# SERVICE PARTS LIST

**BULLETIN NO.**  
**54-26-1775**

SPECIFY CATALOG NO. AND SERIAL NO. WHEN ORDERING PARTS		REVISED BULLETIN	DATE
<b>3/4" D.I. IMPACT WRENCH</b>			Oct. 2003
CATALOG NO. <b>9075-20</b>	STARTING SERIAL NO. <b>239A</b>	WIRING INSTRUCTION <b>58-01-1820</b>

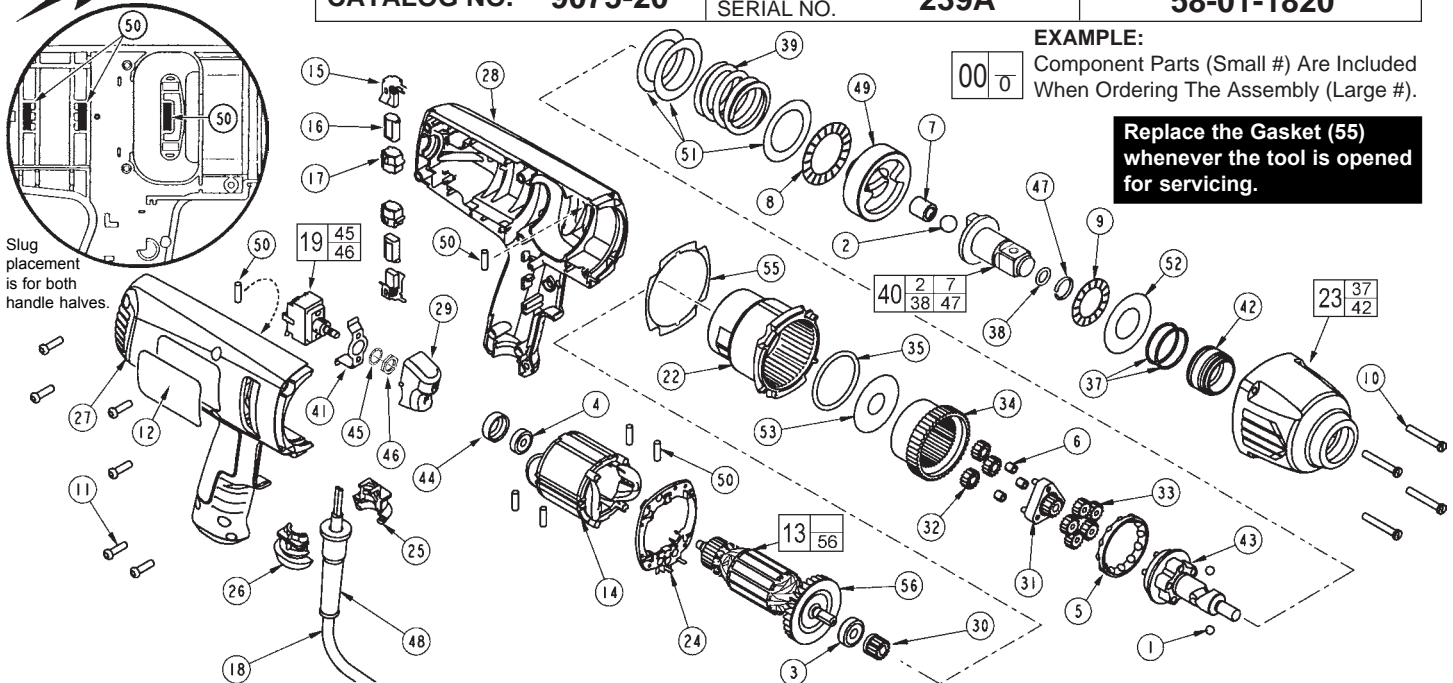
Milwaukee is providing a **no-charge** warranty service to owners of **9070-20, 9071-20, and 9075-20 Impact Wrenches**. We are taking this action because under certain circumstances the cord set of the Impact Wrench may pull out of the handle, which poses a risk of injury or electrocution.

For operator safety a **9070-20, 9071-20 or 9075-20 Impact Wrench** within the listed serial number ranges **require original equipment 31-17-0265 Cord Clamp to be replaced with a 31-17-0270 Cord Clamp.**

As an aid to determining the cord clamp in a tool, the 31-17-0270 Cord Clamp has the numbers **'0270'** molded into the clamping rib. The 31-17-0265 Cord Clamp has no markings on the rib.

If the tool contains a 31-17-0265 Cord Clamp, please return your Impact Wrench to the nearest Milwaukee **factory** Service Center or Authorized Service station for no-charge warranty replacement of the cord clamp.
